Subject: Lap Bar Cylinder Mounting Position

SERVICE BULLETIN

S.B. Number: 92-6 Sheet 1 of 2

Figure 1.

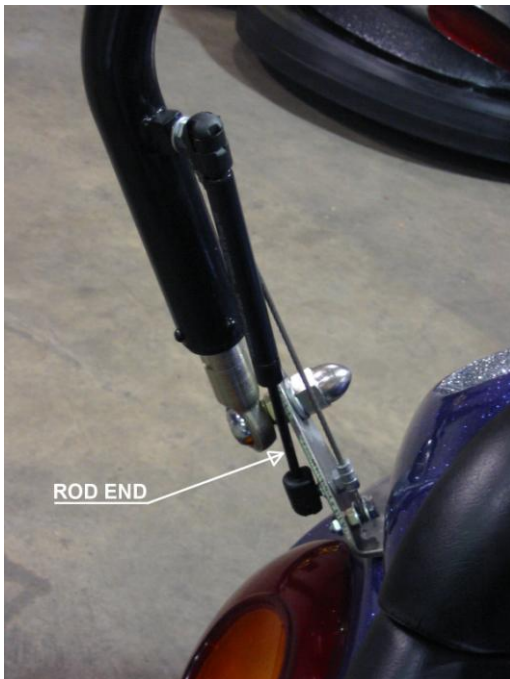
It has been brought to our attention that if the spring cylinder, in the lap bar, is mounted in a reversed position; the lubricating oil inside the cylinder will be drained away from the rod bushing, which could cause premature failure of the cylinder.

All customers with Majestic lap bars installed in their scooter bumper cars are being notified by this service bulletin to reverse their cylinders so that the rod end of the cylinder will be in the position as shown below in Figure 1, or Figure 2 (depending on the style of lap bar installed).

The cylinder can be removed by inserting a screwdriver or knife under the spring clip on the end of the cylinder and prying it up, which will release the cylinder end from the ball stud. After reversing the cylinder, push the spring clip down to secure the cylinder to the ball stud.
